ADDENDUM 04

December 4, 2015

College of Fine Arts Infrastructure Upgrade

Ohio University

1 B1 FLOOR PLAN
1/8" = 1'-0"

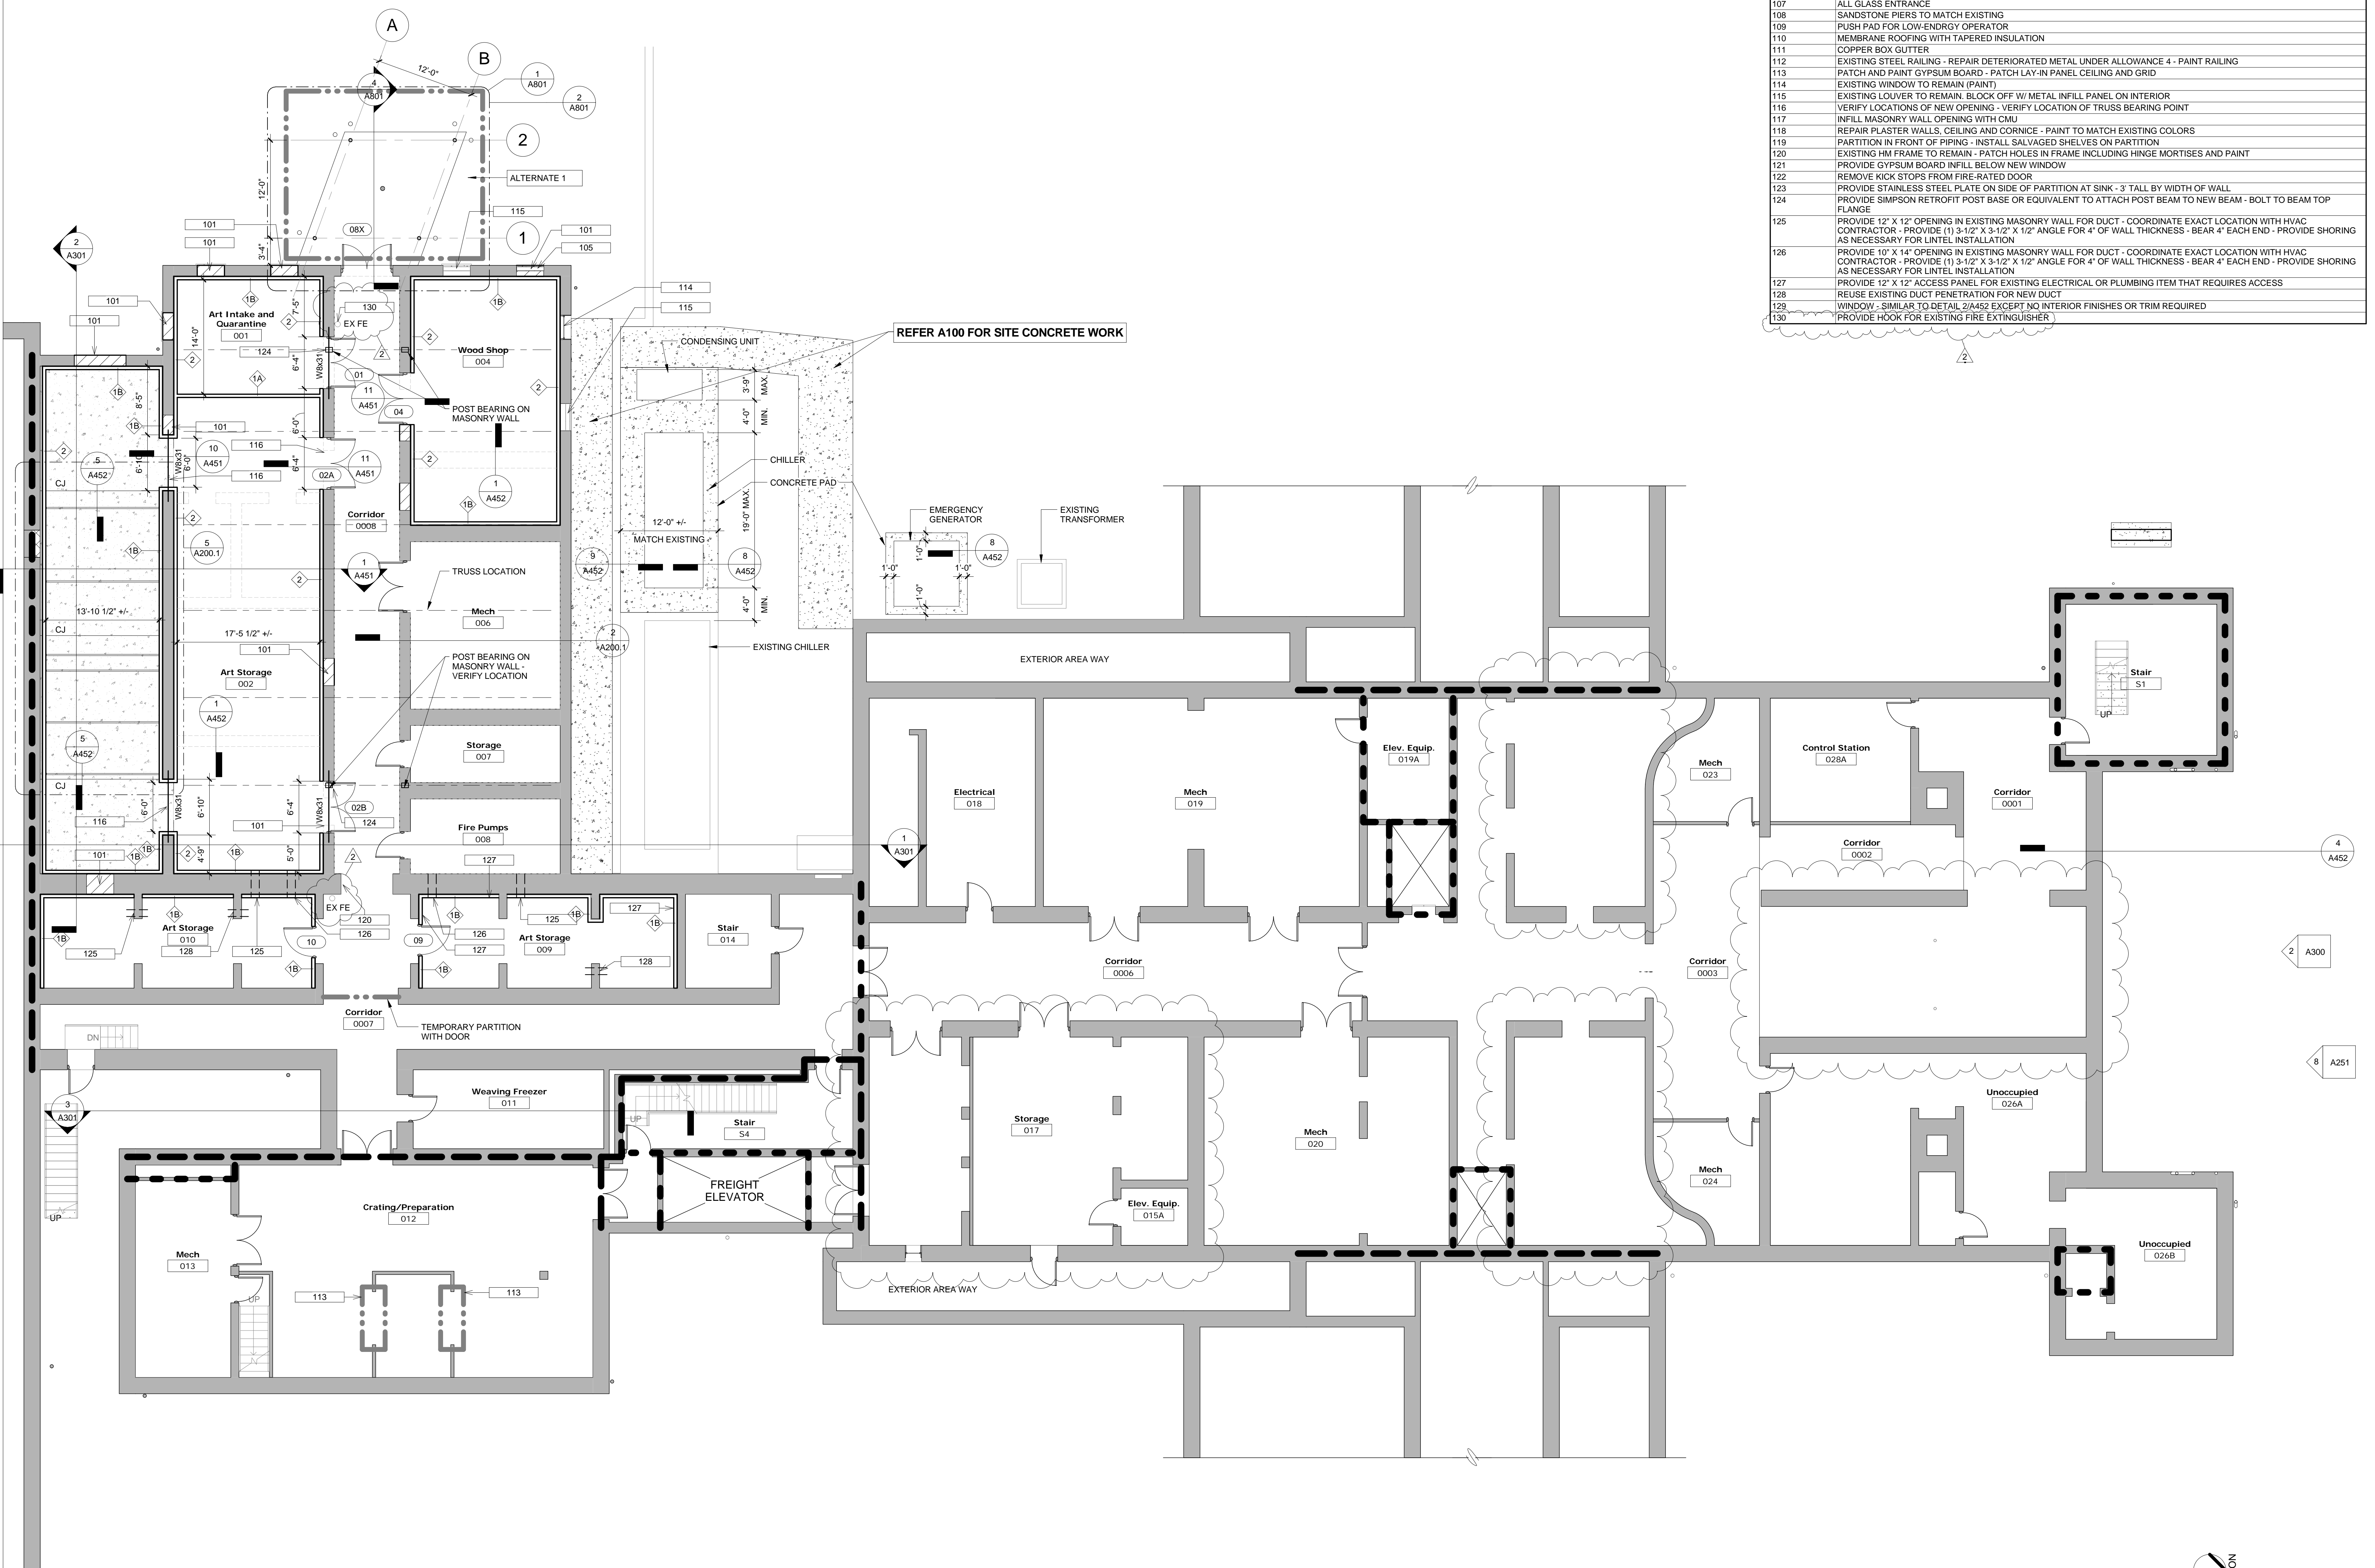
2. DRAWING A200 – BASEMENT PLAN – Add existing fire extinguisher locations and remove Alternate 2.
3. DRAWING A205 – ROOF PLAN – Add requirement for R-20 rigid insulation and add keynote on low-slope roof.
4. DRAWING A451 – BUILDING ENVELOPE DETAILS – Rigid insulation shown shall have a minimum r-value of 20.
